LiDAR Quality Assessment Report

TN NRCS 2011

NGTOC

2014-02-18

Checkpoint Distribution Image

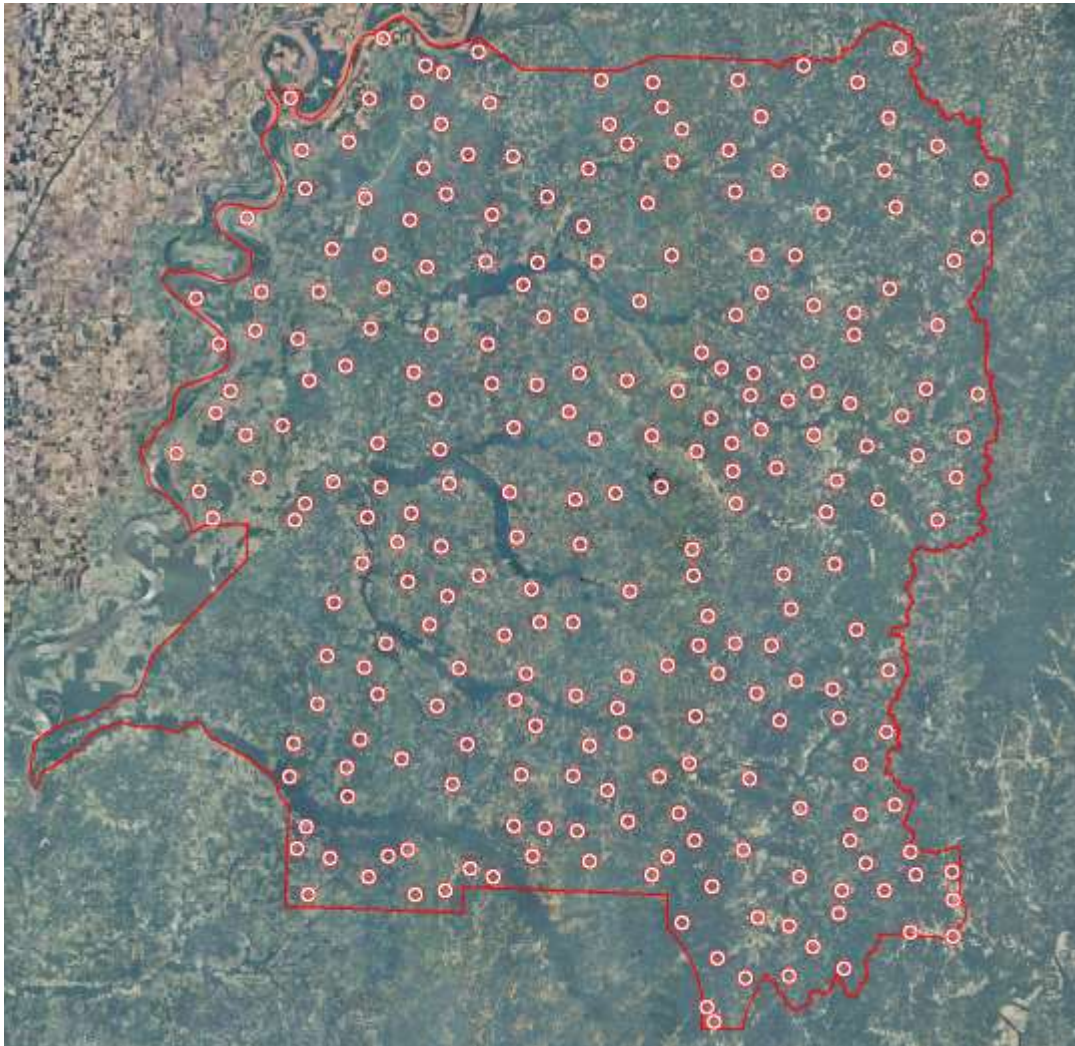
Reports and metadata indicate that Dewberry tested the classified LiDAR instead of the DEM. Therefore vertical accuracy has not been accepted.

Based on this review, the USGS does not accept the vertical accuracy.
